From: "Selim" <Selim@sawayaeng.com>
To: "'Ron Dragoo'" <RonD@rpvca.gov>
Cc: "SoK@rpvca.gov" <SoK@rpvca.gov>, "Jill Martin" <jmartin@trumpnational.com>, "'Ara Mihranian'" <AraM@rpvca.gov>, "Scott Campbell" <scampbell@trumpnational.com>
Subject: 2019-06-18 # Tract 50666 # Request for Storm Drain Amendment

Re: **Request to use Forestall Canyon to convey off-site storm water in lieu of the proposed 60 inch Reinforced Concrete Pipe.**

EXHIBIT "A"
TRACT 50666
PRE-DEVELOPMENT
EXISTING STORM DRAIN

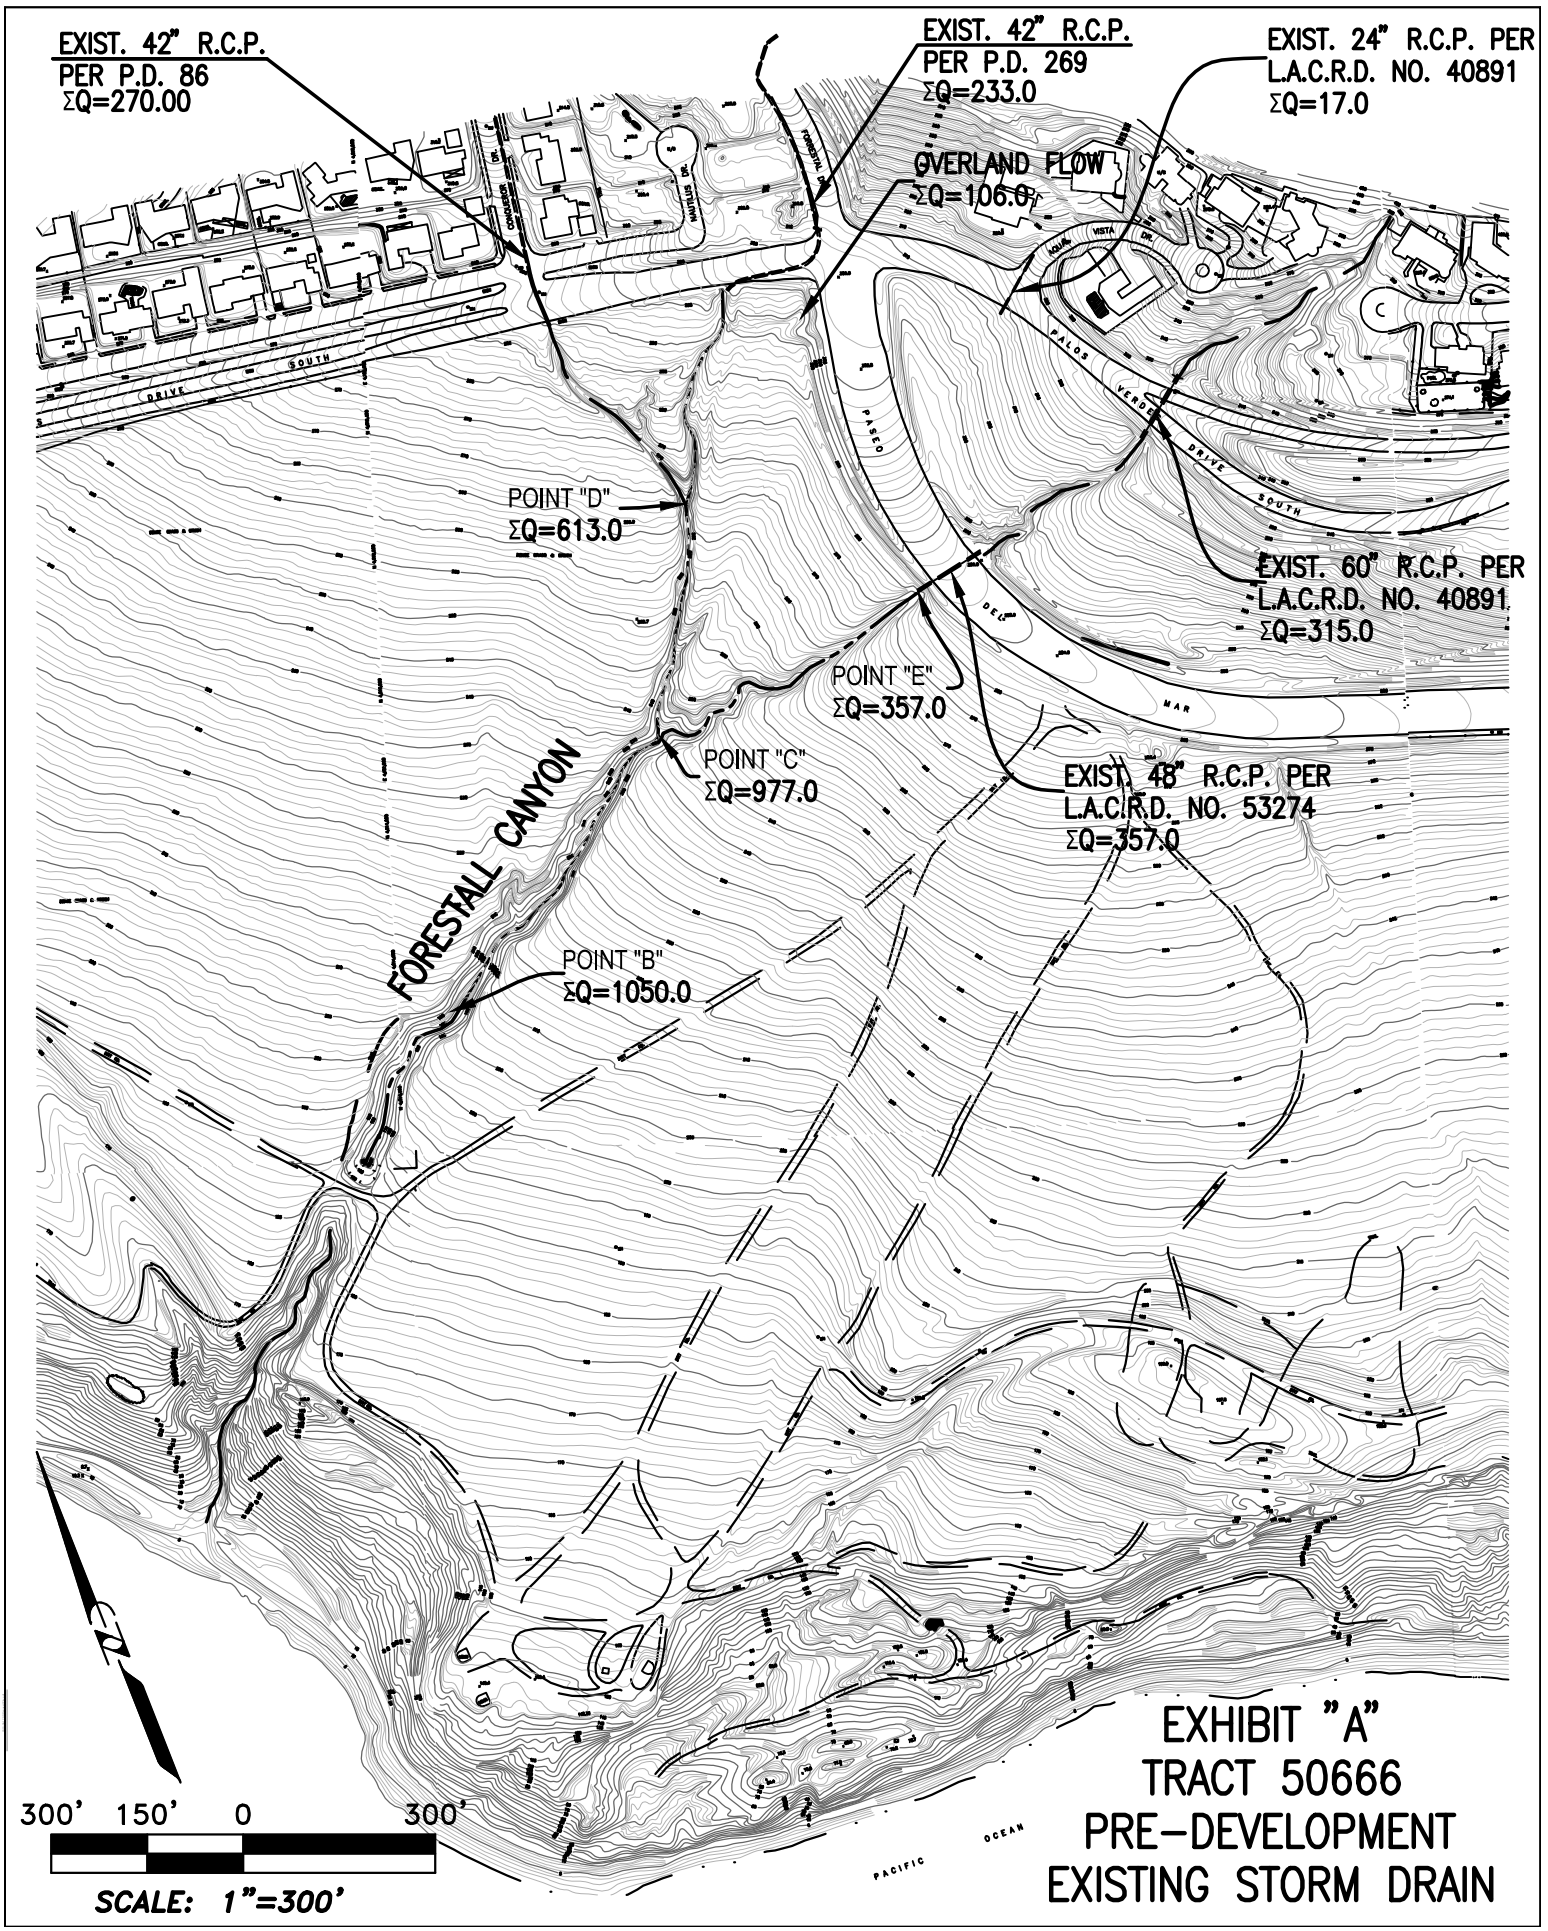
Three different storm drain systems were constructed to outlet to Forestall Canyon to ultimately convey the off-site flow to the ocean. Historically, the flow in Forestall Canyon ranged from 613.0 cfs at Point "D" to 1050.0 cfs. At Point "B" (see Exhibit A).

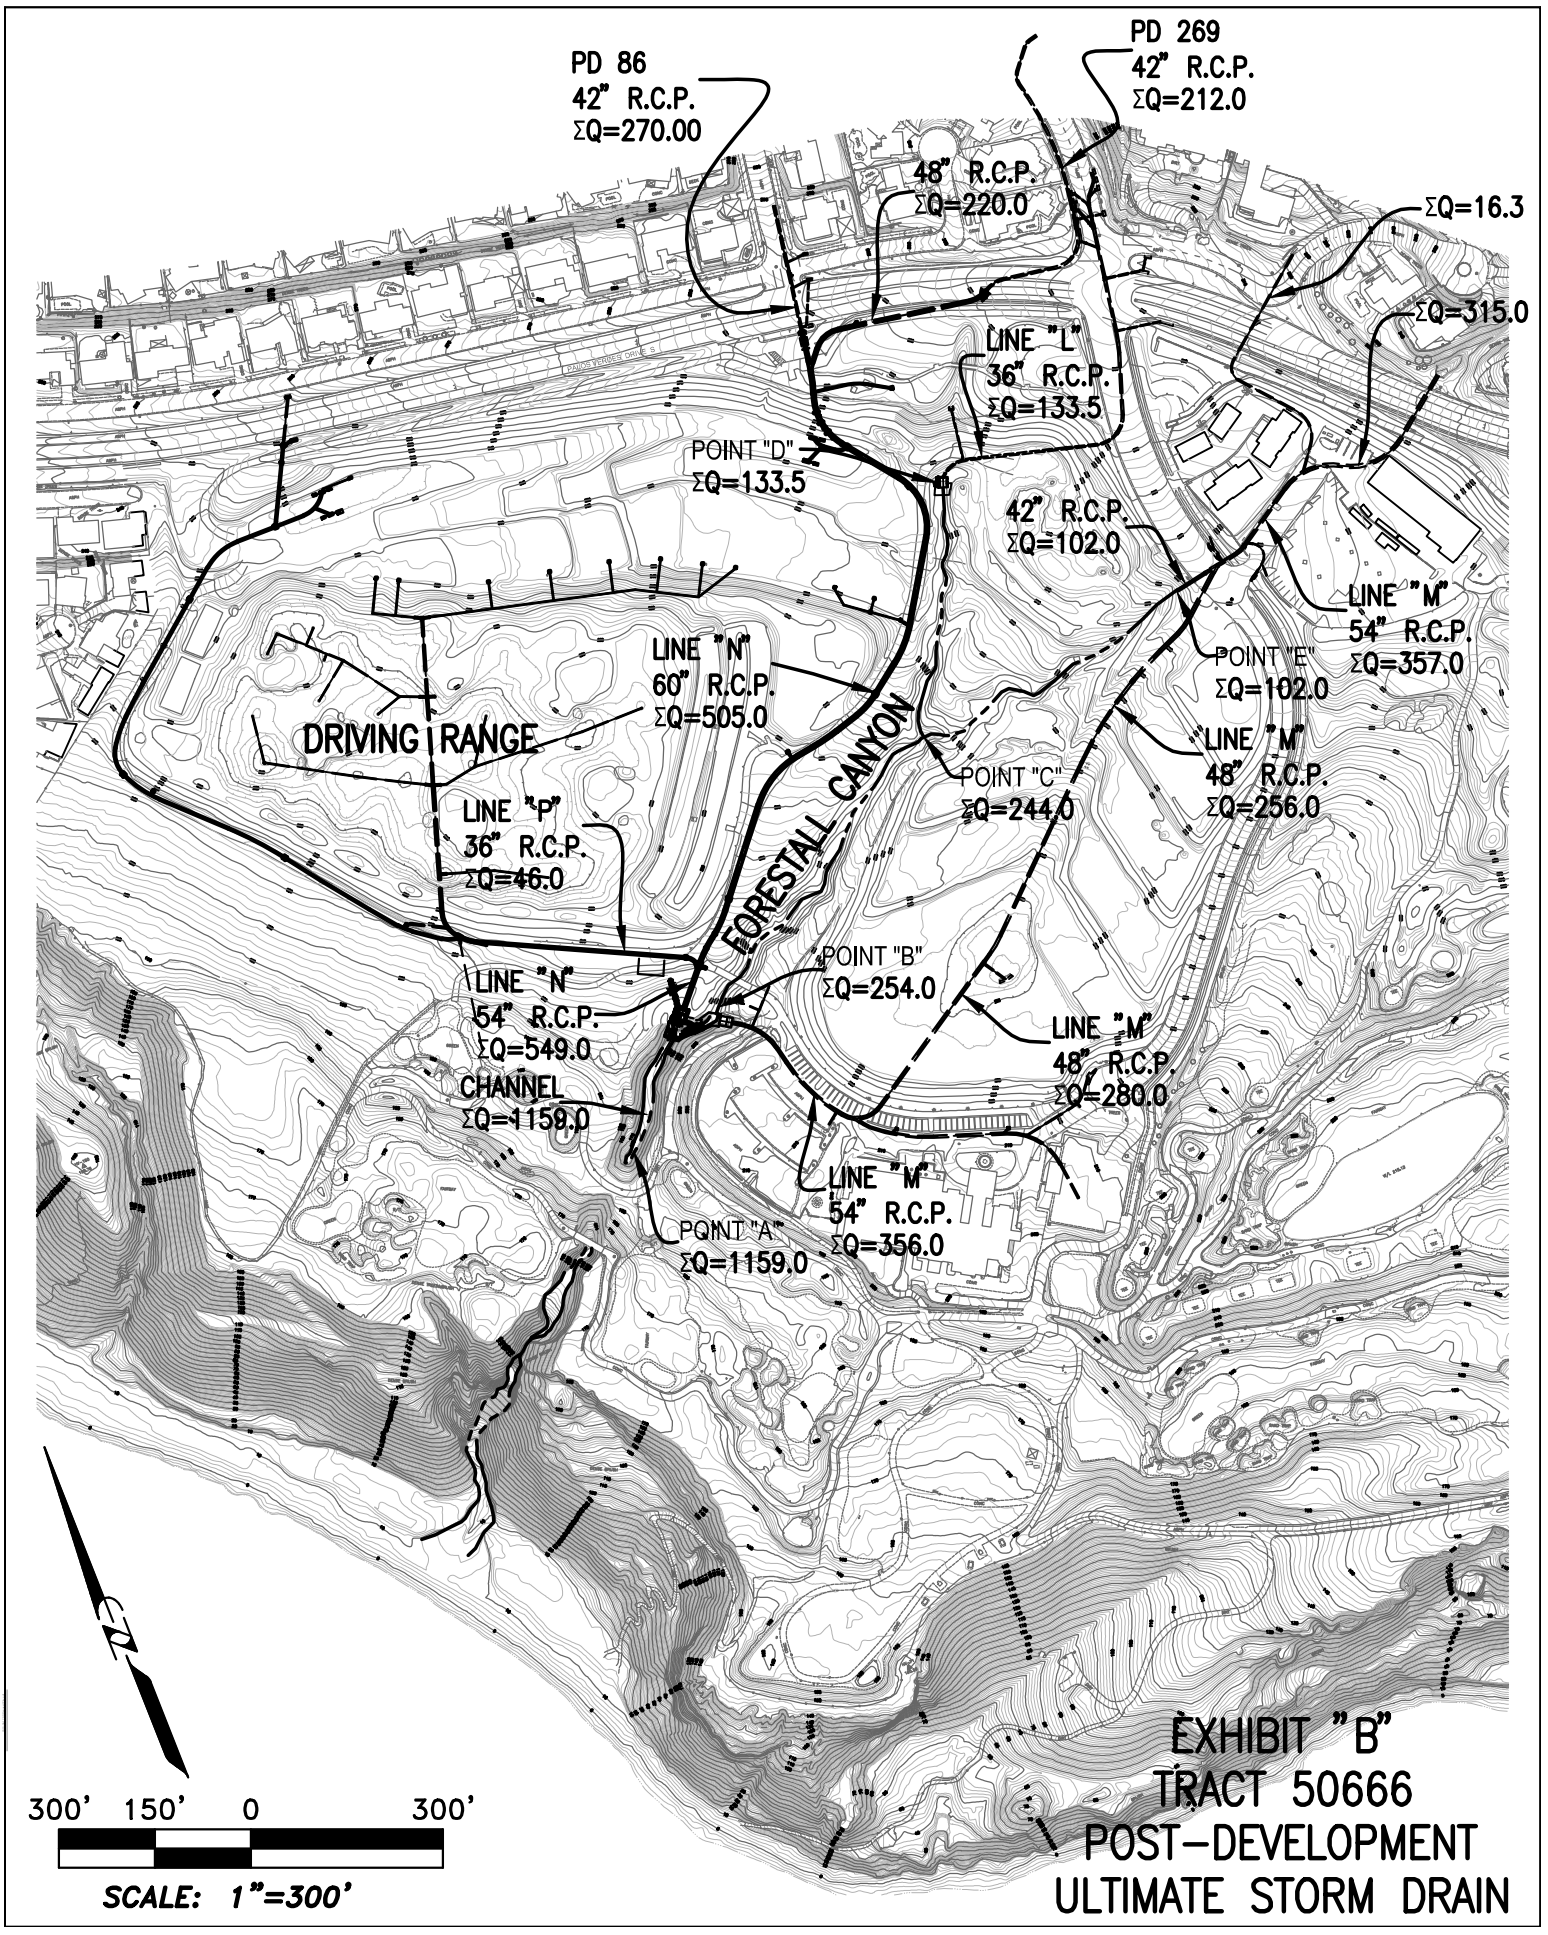
The Drainage Concept of the development as proposed in 2000 and shown on Exhibit "B" was set to reduce / minimize the risk of flooding of the proposed lots from Forestall Canyon. As a result, the flow within Forestall canyon was reduced from 1050.0 cfs at Point "B" to approximately 254.0 cfs. The balance of approximately 800 cfs was to be conveyed back to Forestall Canyon downstream of the proposed lots at Point "B" via a storm drain piping system.

The storm drain systems per PD 86 and PD 269 were existent prior to the development. Line "L" and Line "M" were constructed in 2004 and have been in operation since. The only remaining storm drain lines to be constructed for the development to satisfy the approved Drainage Concept are Line "N" and line "P" (See Exhibit "B").

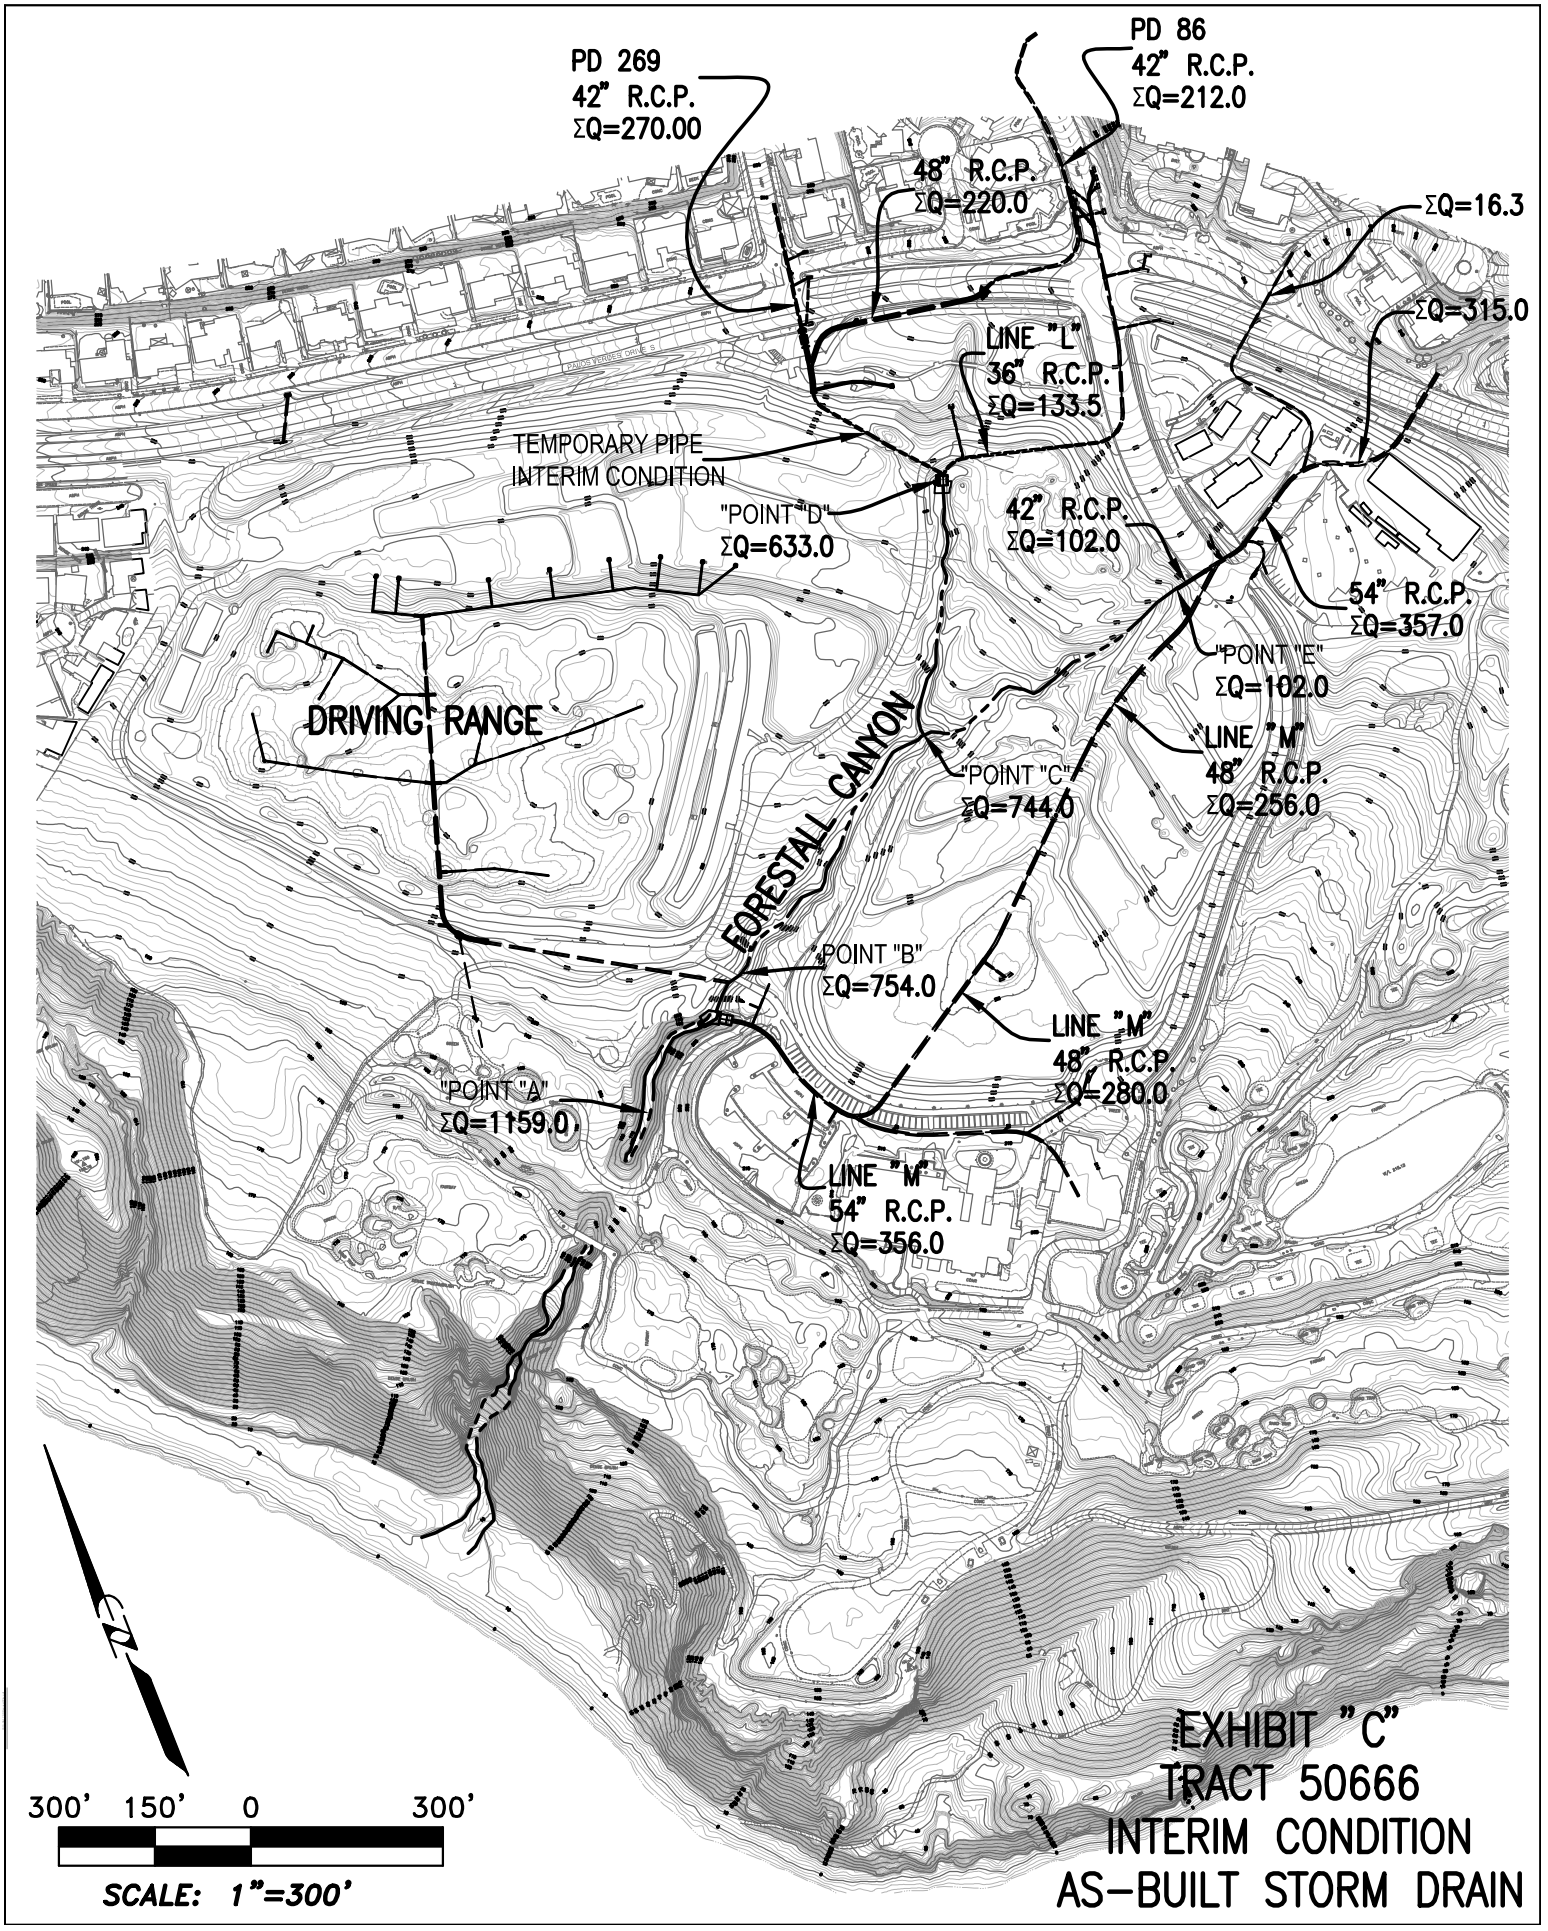
In the interim and until the ultimate drainage system is completed, a temporary pipe was constructed in 2005 to convey the flow of PD 86 and PD 269 back to Forestall Canyon (See Exhibit "C"). Since 2005, (approximately 15 years), the flow within Forestall Canyon between Point "D" and Point "B" has ranged from 633.0 cfs to 754.0 cfs, which is below the historical / predevelopment flow of 1050.0 cfs.
